**FCPS NEW MIDDLE SCHOOL – POLO CLUB**  
**KDE BG # 21-176**  
**FCPS BID # 20-21**  
**JRA Project No. 202078**  
Fayette County Public Schools  
Lexington, Kentucky

The Addendum will form a part of the Contract Documents and modifies the original Bidding Documents dated September 2021.

**FP-111A**

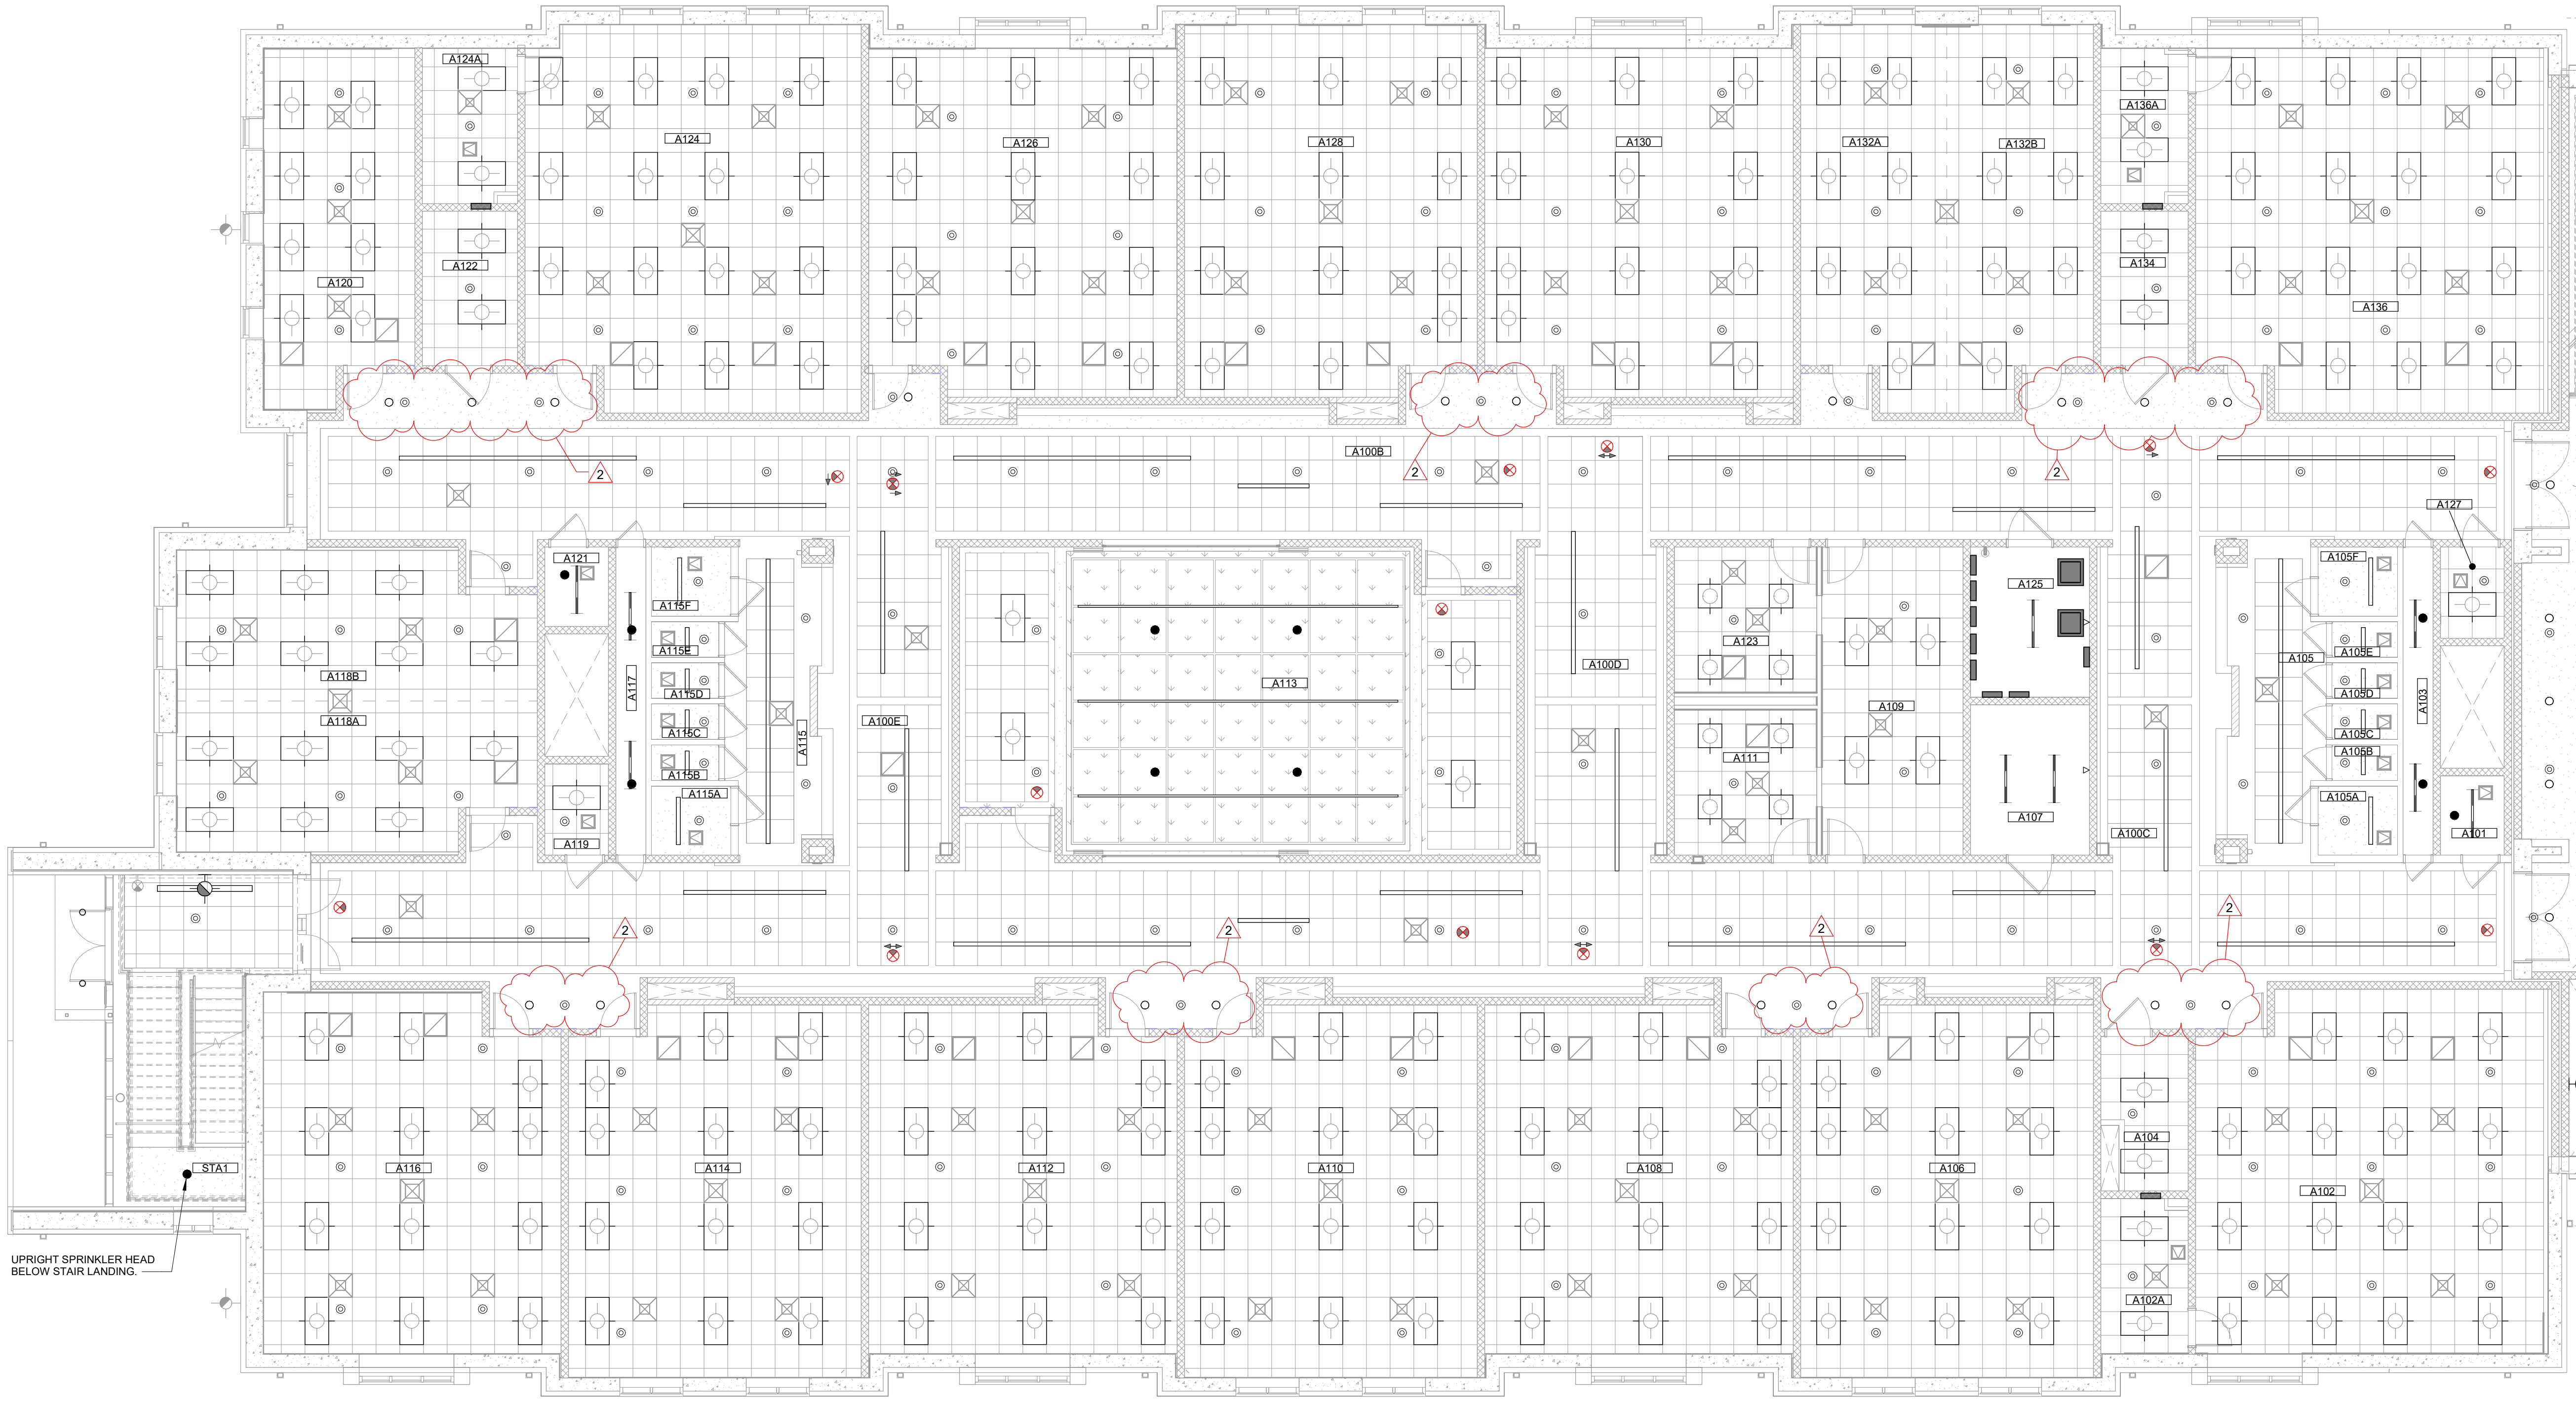
Refer to sheet FP-111A adjust Sprinkler Head locations as indicated.

**A** FIRST FLOOR FIRE PROTECTION PLAN - AREA D  
SCALE: 1/8" = 1'-0"

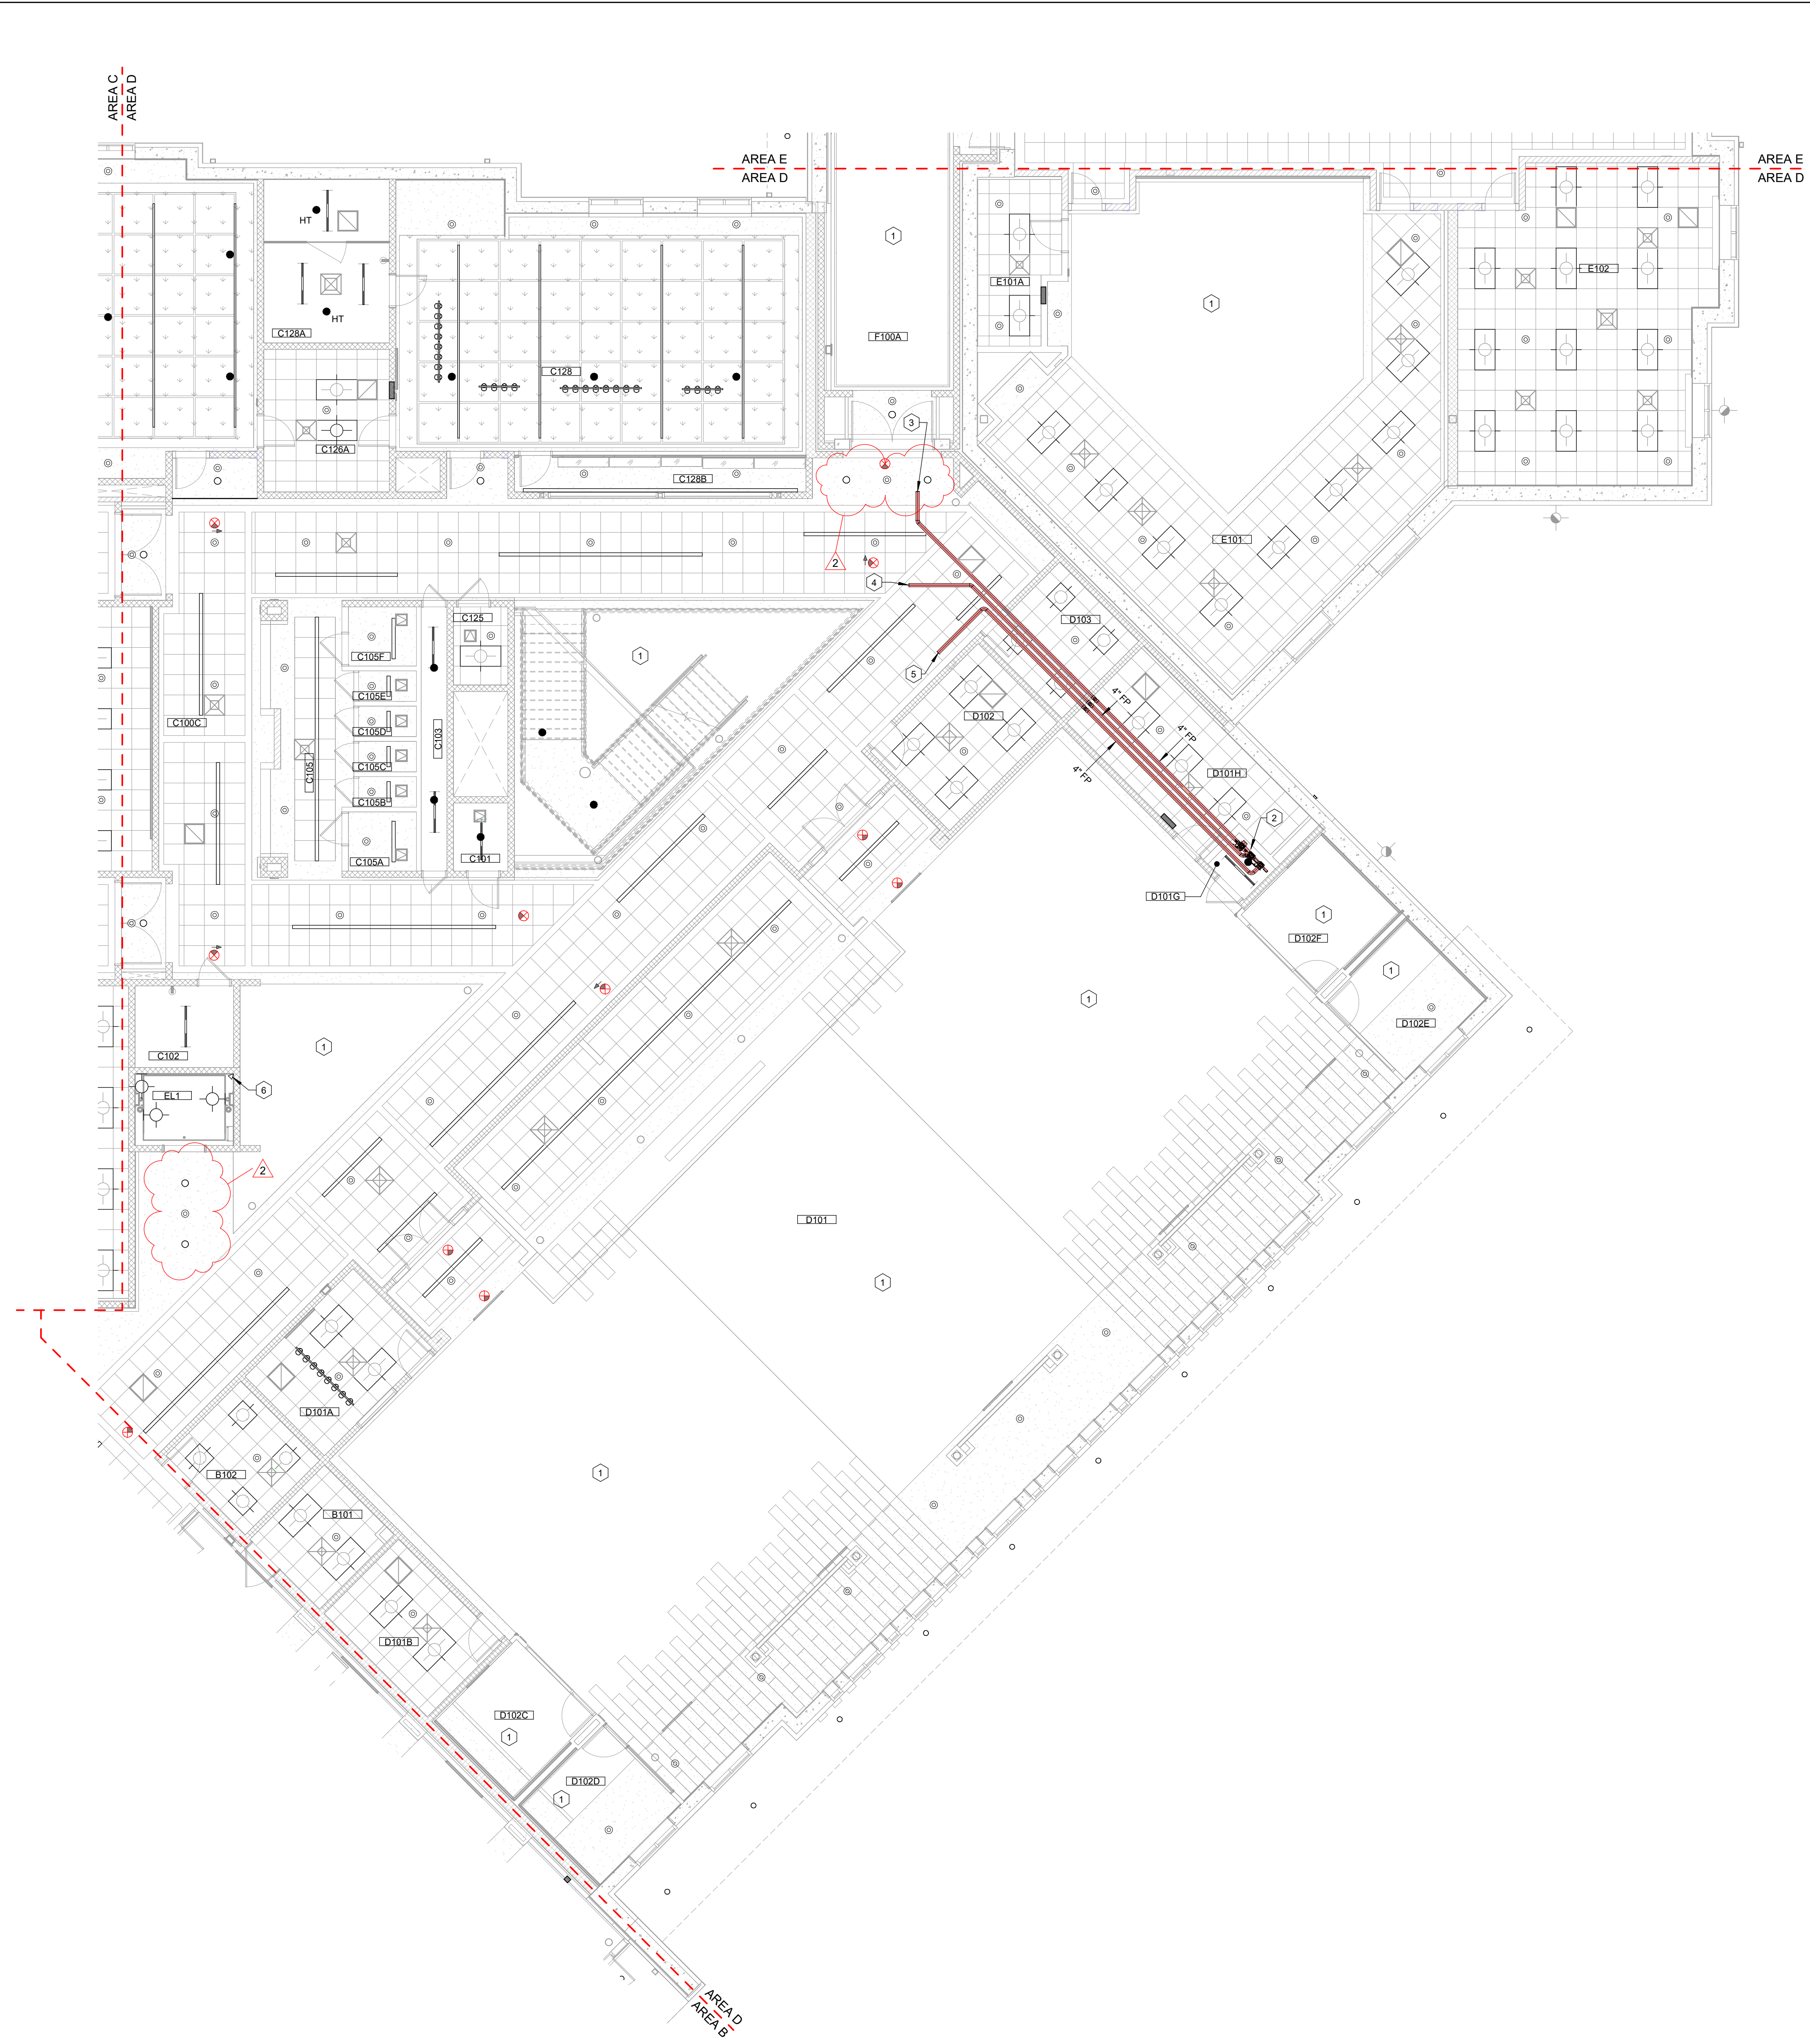
Refer to sheet FP-111D adjust Sprinkler Head locations as indicated.

**FP-111E**

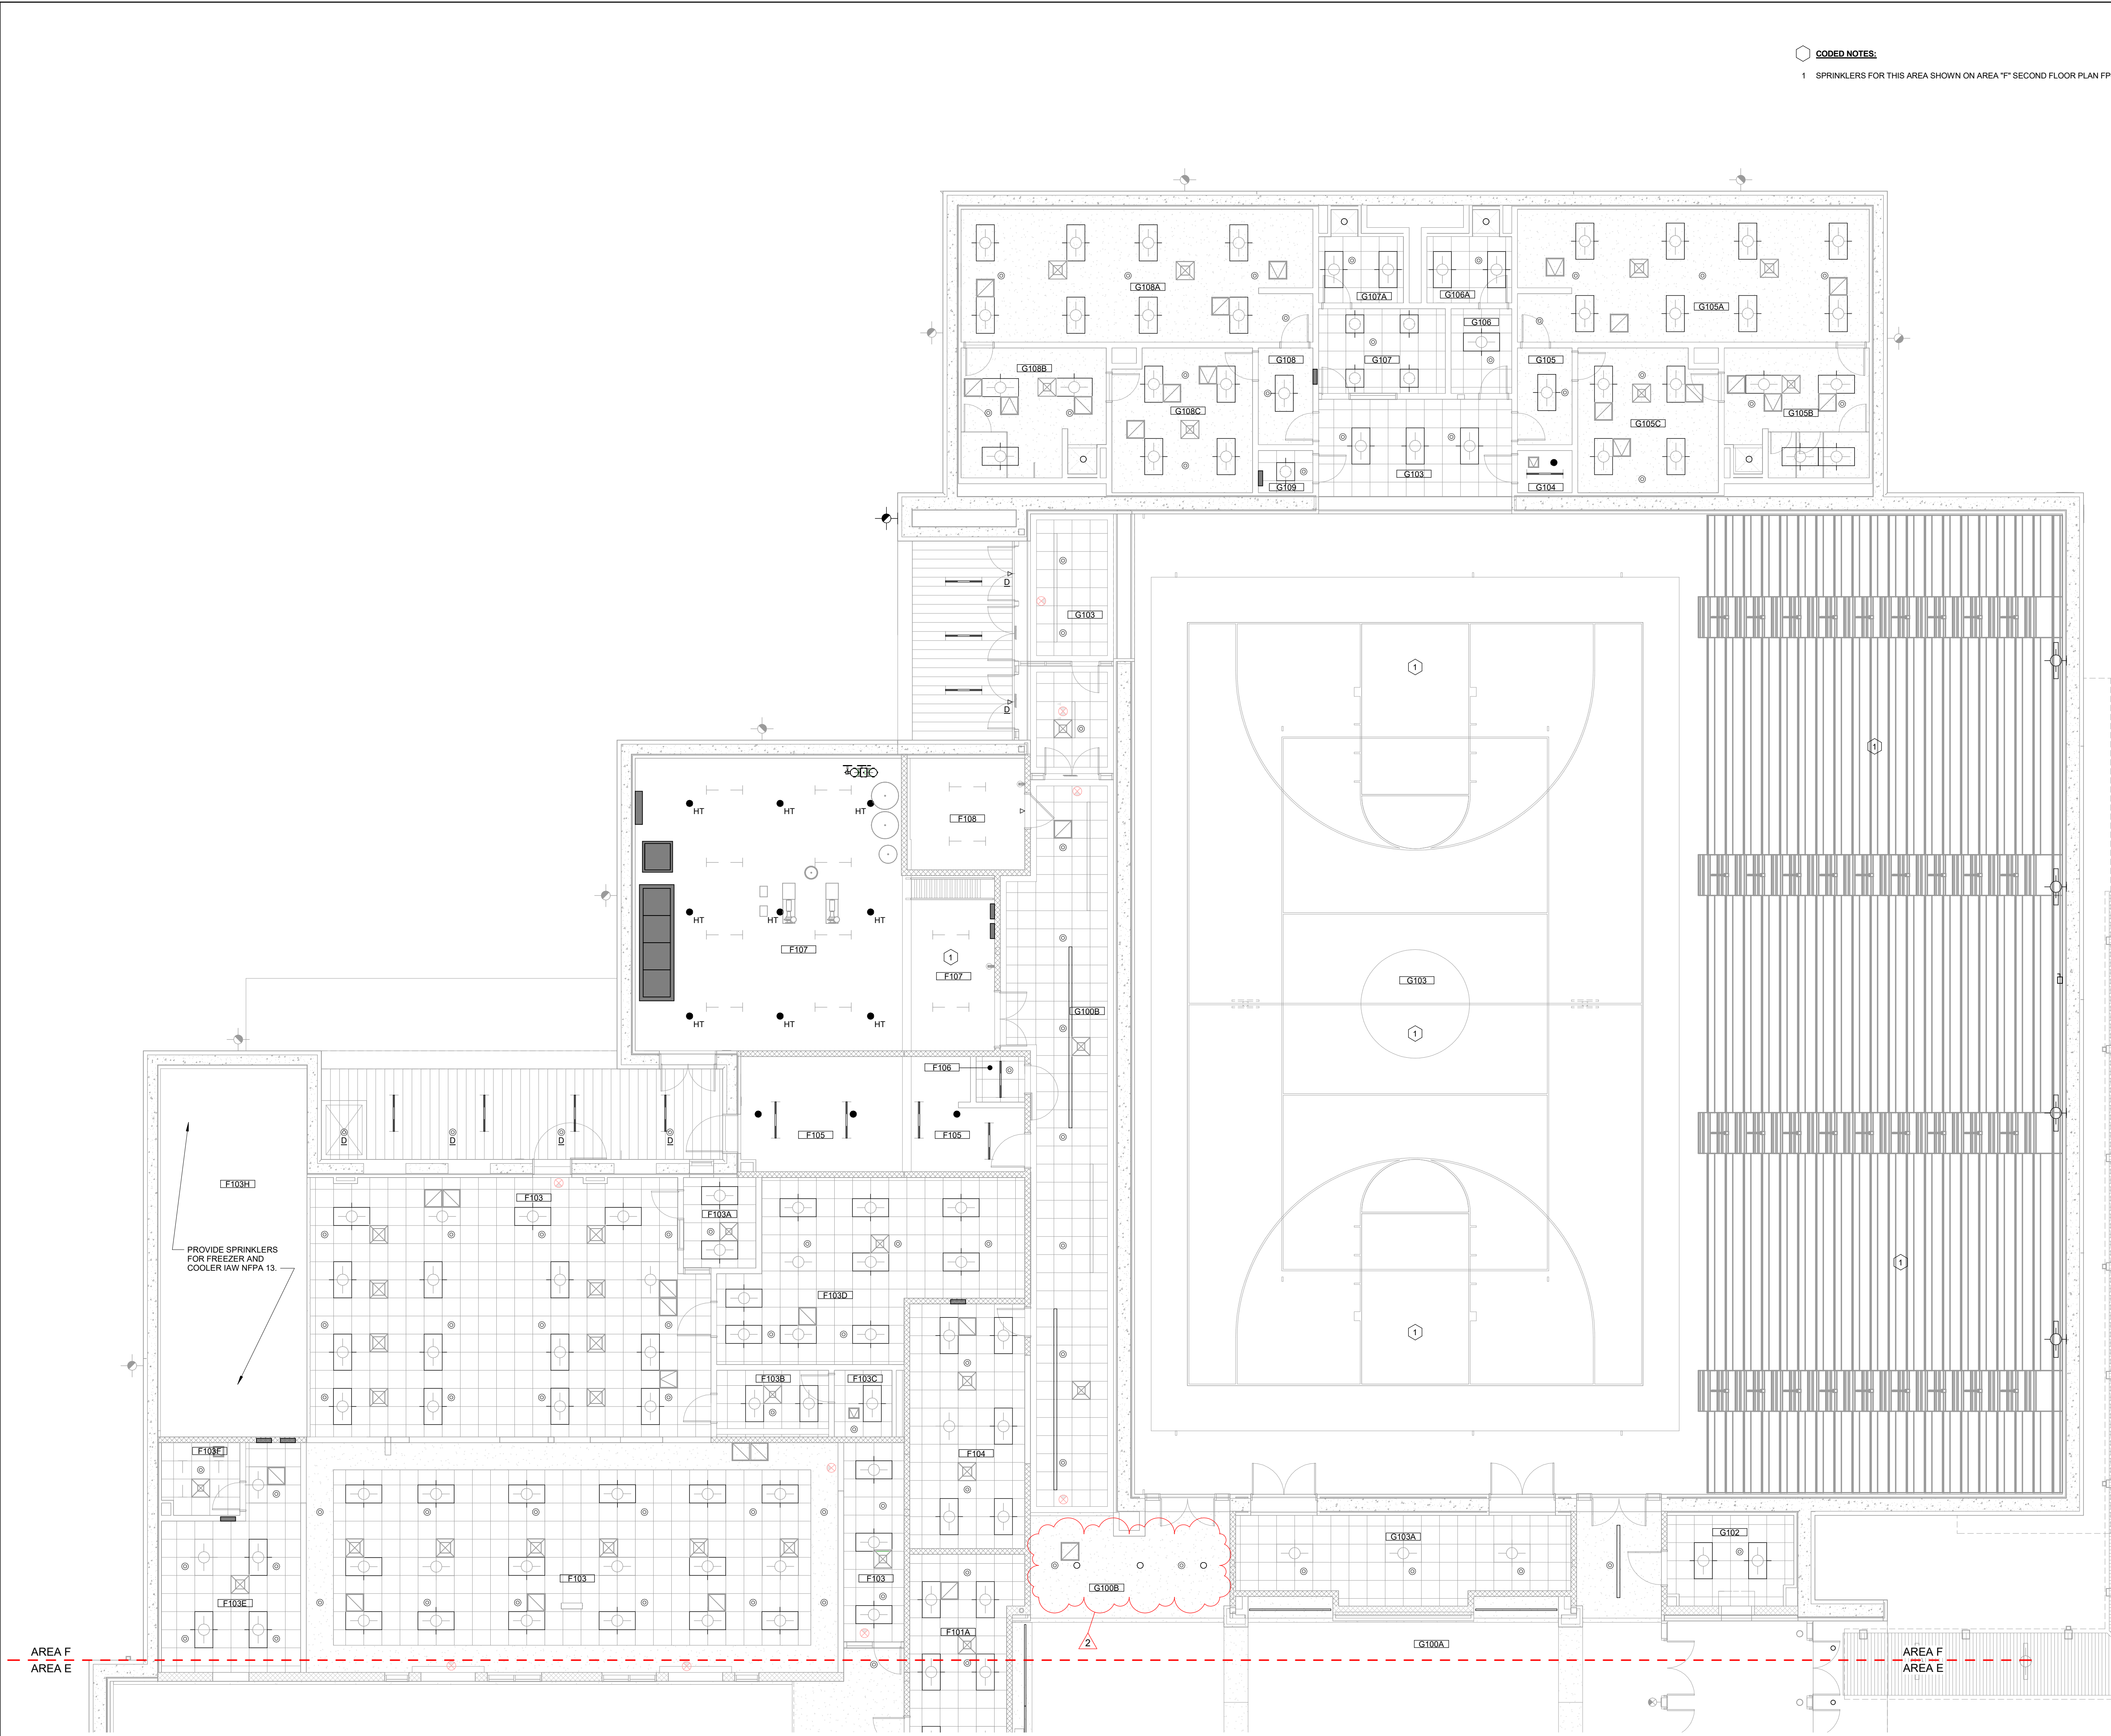
Refer to sheet FP-111E adjust Sprinkler Head locations as indicated.
